# **Argosy Property No 1 Limited**

Legal submissions on behalf of Argosy Property No 1 Limited (submitter 383)

Dated 5 May 2023

Figure A: Encroachment of adjoining property into viewshaft, as shown in the Proposed District Plan maps

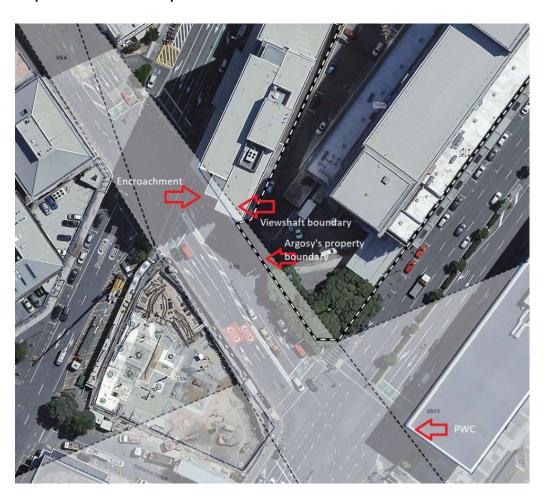
- 53. In relation to Viewshaft 3 Whitmore Street, Ms Popova suggests that because these viewshafts were reviewed in 2020 and that review did not establish the need for any changes, none are required.<sup>32</sup> Ms Popova explains that the PWC building frames the left margin of the view and realignment of that margin could narrow the extent of the viewshaft frame.<sup>33</sup>
- 54. However, there has been no recent analysis undertaken. Photos of the area show that the building adjoining 7 Waterloo Quay has recently been developed and is encroaching into the viewshaft (as shown in **Appendix B**). As shown in Figure A below, the left margin of the viewshaft has essentially been realigned by this development so it now follows the road corridor rather

- than the viewshaft boundary shown in the Proposed Plan. The viewshaft extends over Argosy's site by a width of approximately 4m for the full frontage along Whitmore Street, this is a significant area.
- 55. Realigning the boundary of this viewshaft so that to does not encroach on Argosy's site is justified because there are no implications for doing so; the viewshaft has already been encroached and any development on Argosy's site, to the property boundary would not further affect the viewshaft.

Retaining it simply because of the 2020 review is not fair or reasonable.

### **Viewshaft 3 – Whitmore Street**

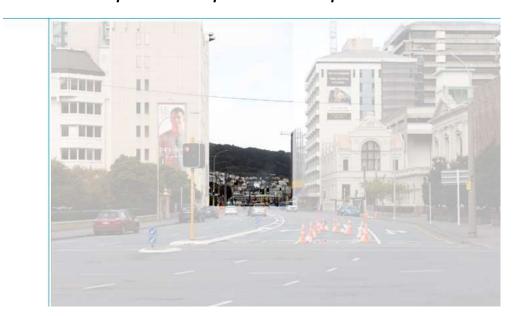
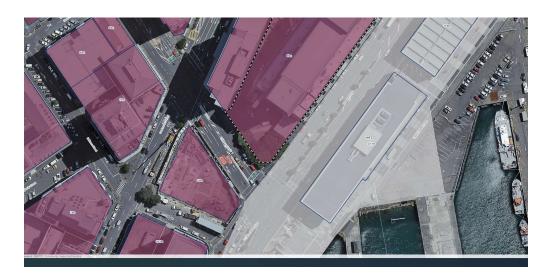
- 51. Argosy's site at 7 Waterloo Quay is subject to Viewshaft 3 Whitmore Street, and Argosy's site at 360 Lambton Quay / 8-14 Willis Street is subject to Viewshaft 9 Lambton Quay. Argosy sought that these viewshafts be reviewed so that they do not encroach onto these sites, and otherwise that no further encroachment occurs.

## Viewshaft 9 - Lambton Quay

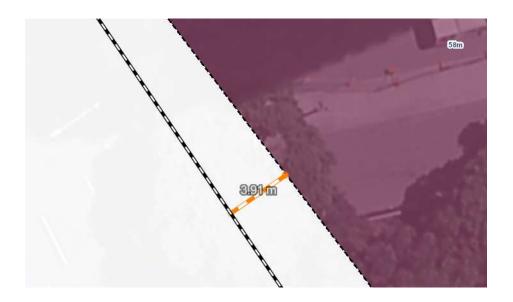
- 56. In relation to Viewshaft 9 Lambton Quay, Ms Popova explains that the part of the building that "falls within the overlay covers only the parts of the site located around the street corner. If the right margin is amended to exclude the property at 360 Lambton Quay from the Vs9 overlay, as sought by the submission, this will narrow the extent of the protected view and consequently reduce the view to the AON Centre (one of the two focal elements); if or when new development occurs on the site."<sup>34</sup>

- 57. The Aon Centre is recognised because of its contribution to the sense of place in the city, however:
  - (a) views of the building are already limited by other buildings in the area, and it cannot be seen in totality now;

- (b) it can be viewed and will always be prominent in Vs9 due to its corner location on Willis and Willeston Streets. Amending the viewshaft at 360 Lambton Quay will not affect the buildings' ability to be seen as a landmark building from Vs9; and

- (c) imposing a development control on 360 Lambton Quay / 8-14 Willis Street of up to 7.5m in width is onerous in the context of the reasons for and focal point of this viewshaft.
